SAFETY ALERT

Engine Mount Bolts

**SA-ASTM-CT__-01;
SA-ASTM-CT2k-01;
SA-ASTM-CTSW-01**

FLIGHT DESIGN USA SAFETY DIRECTIVE No.8

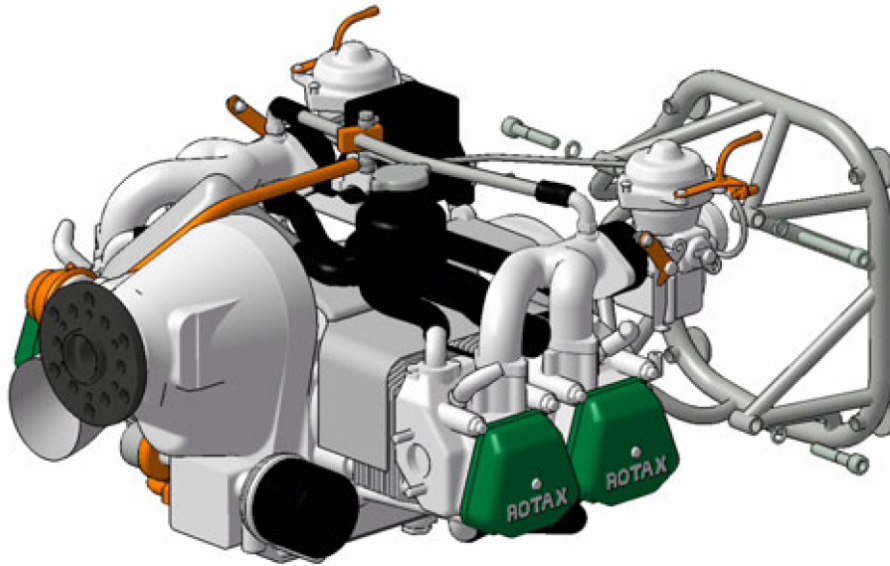
Three aircraft were found to have partially loosened engine mount bolts that connect the Small Engine Frame to the engine.

Change the torque moment of the bolts (part No. C9996511 & C9996098F), which connect the Small Engine Frame to the engine. The original torque moment was 30 Nm. (22ft.lbs). The new Rotax recommended values are a minimum of 35 Nm. (25.8ft.lbs), not to exceed 40 Nm. (29.5ft.lbs).

1. Reflect the new torque values
2. Clarify the need to check the engine mount bolts during the specified inspection intervals.
